**RE:**  
**ADDENDUM NO.2**  
**FOR BID NO: 2013-14-08**  
**“DETENTION POND AND RECONSTRUCTION OF**  
**SUGARCANE DRIVE FROM MILE 6 WEST TO MILE**  
**5 ½ WEST”**

# **ADDENDUM NO. 2**

**“DETENTION POND AND RECONSTRUCTION OF SUGARCANE DRIVE FROM MILE 6 WEST TO MILE 5 ½ WEST”**

**BID NO: 2013-14-08**

SUGARCANE RD  
**UTILITY & DRAINAGE LAYOUT**  
STA 10+00.00 TO STA 20+00.00

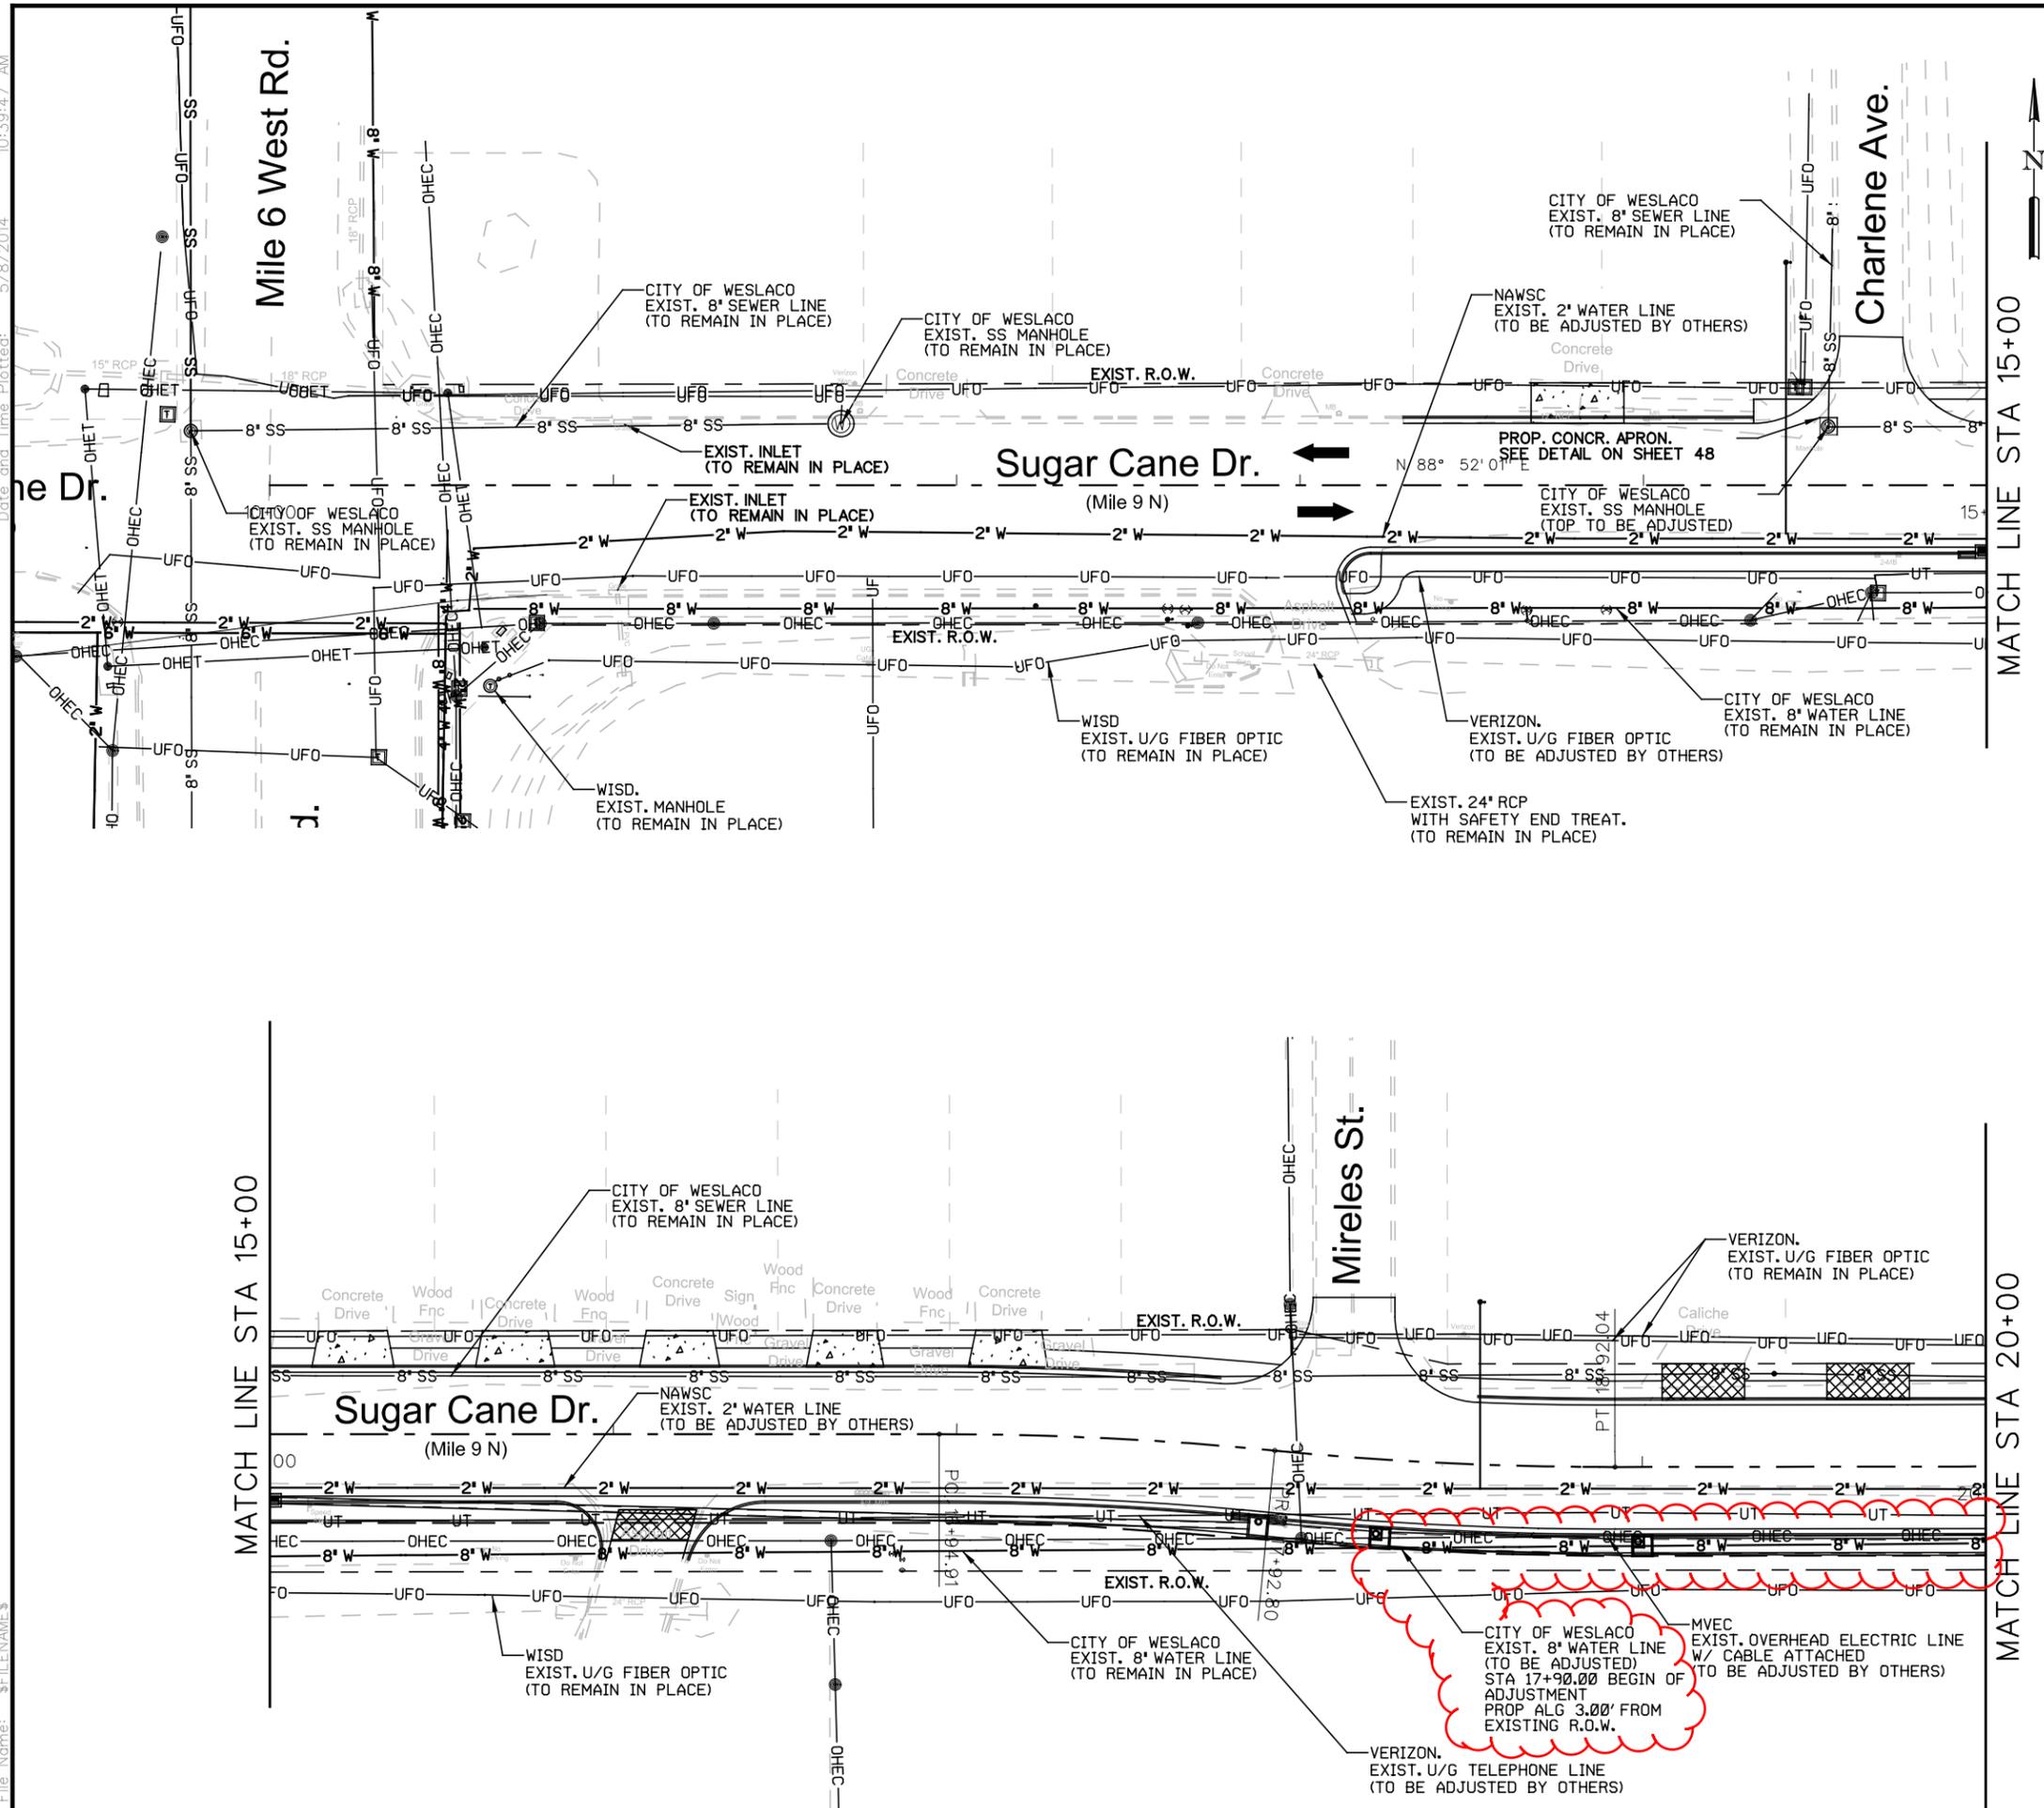
- Updated U&D Sheets depicting the proposed waterline adjustment.
